NFPA 805 Frequently Asked
Questions Program
Public Meeting
July 20, 2006

NATIONAL FIRE PROTECTION ASSOCIATION STANDARD 805 FREQUENTLY ASKED QUESTIONS PROGRAM

See staff comments on NEI 04-02, Draft Rev 2 (February 2006) text (handout). Changes made by NEI were electronically accepted and staff insertions, deletions and comments were made to the "changes accepted" text. In general, where no comments or changes are made by the NRC, the changes made by NEI are acceptable to the staff.

Figure B-1 – Process for Determining if an Active Fire Protection Feature is Required for NFPA 805 Chapter 4 Compliance

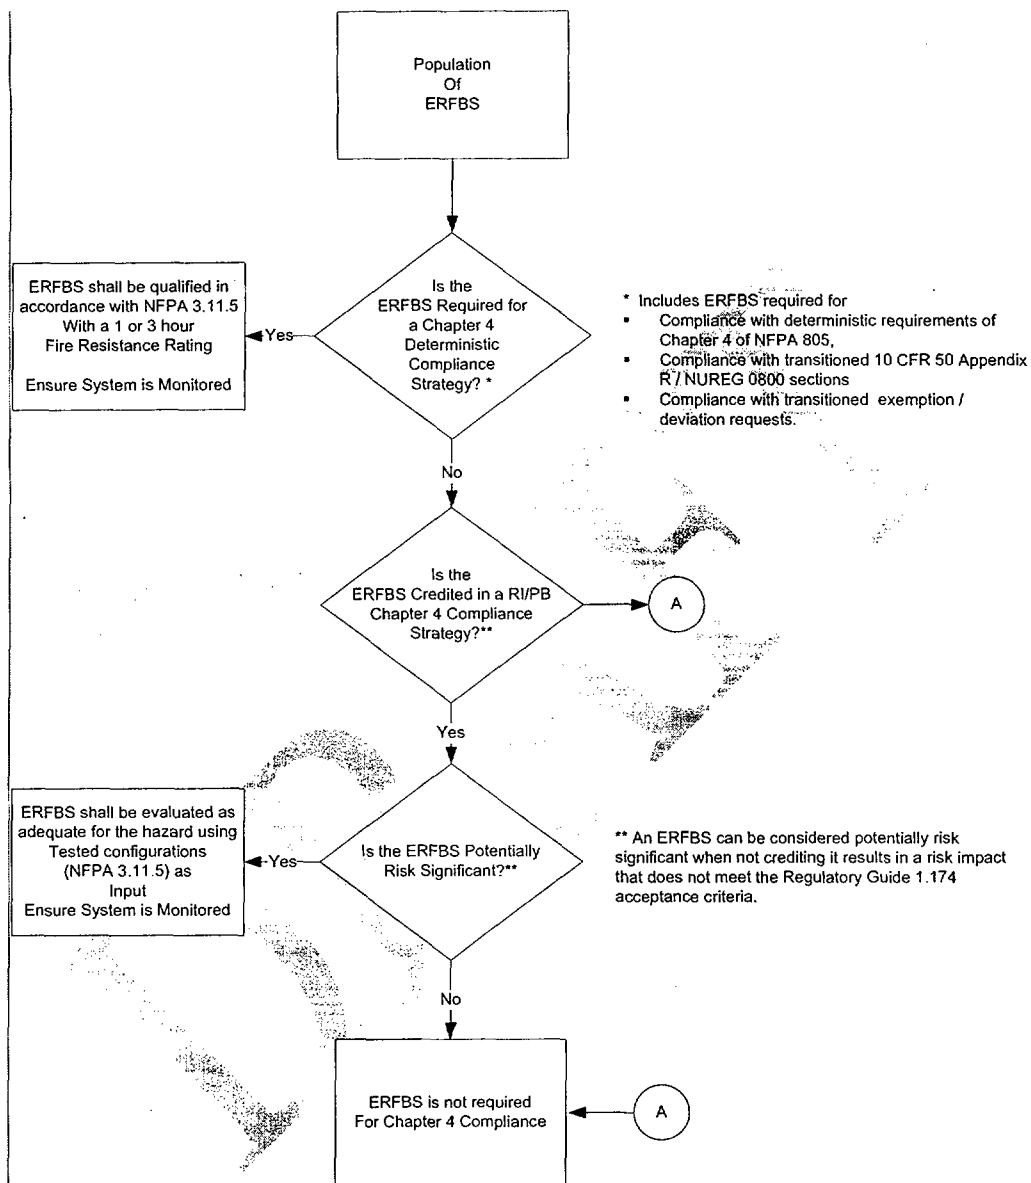
Comment: Acceptance criteria must be included in the licensee's fire protection license condition and must be in accordance with RG 1.205, not RG 1.174 (unless alternative criteria are submitted and approved by the NRC).

Figure B-2 – Process for Determining if an ERFBS is Required for NFPA 805 Chapter 4 Compliance

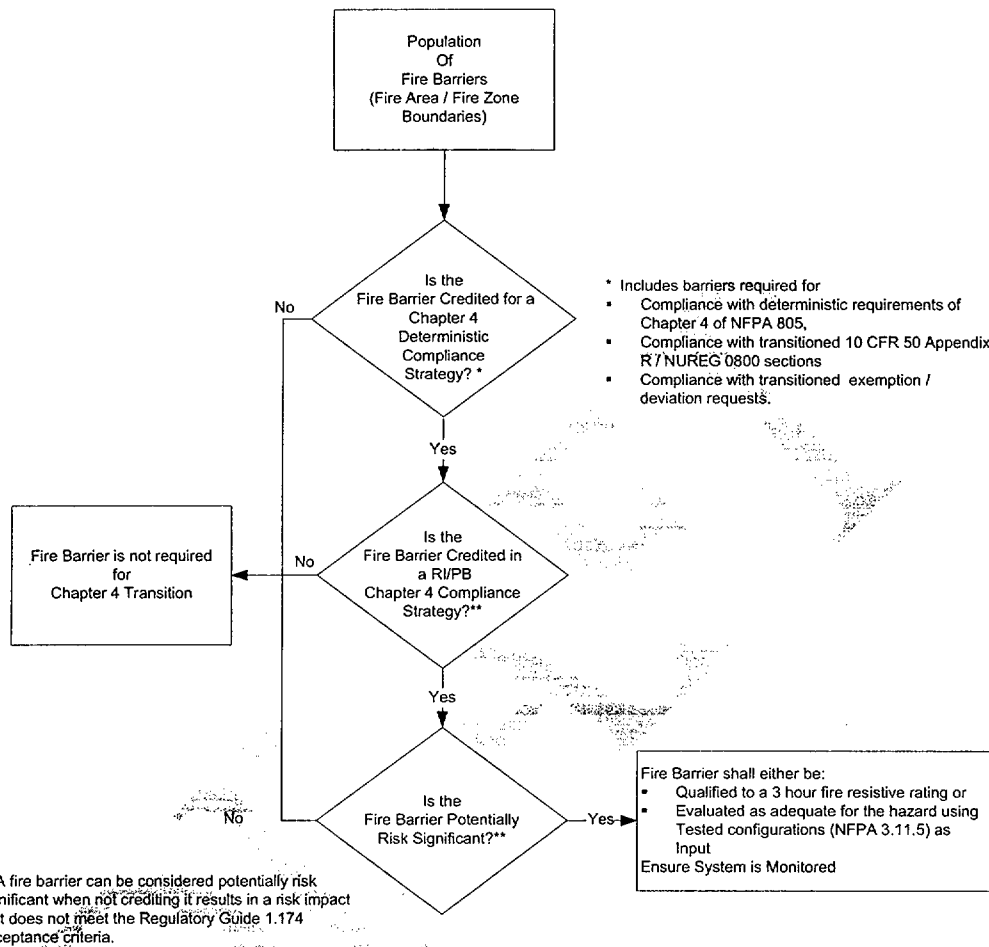
Comment: See comment above on risk acceptance criteria.
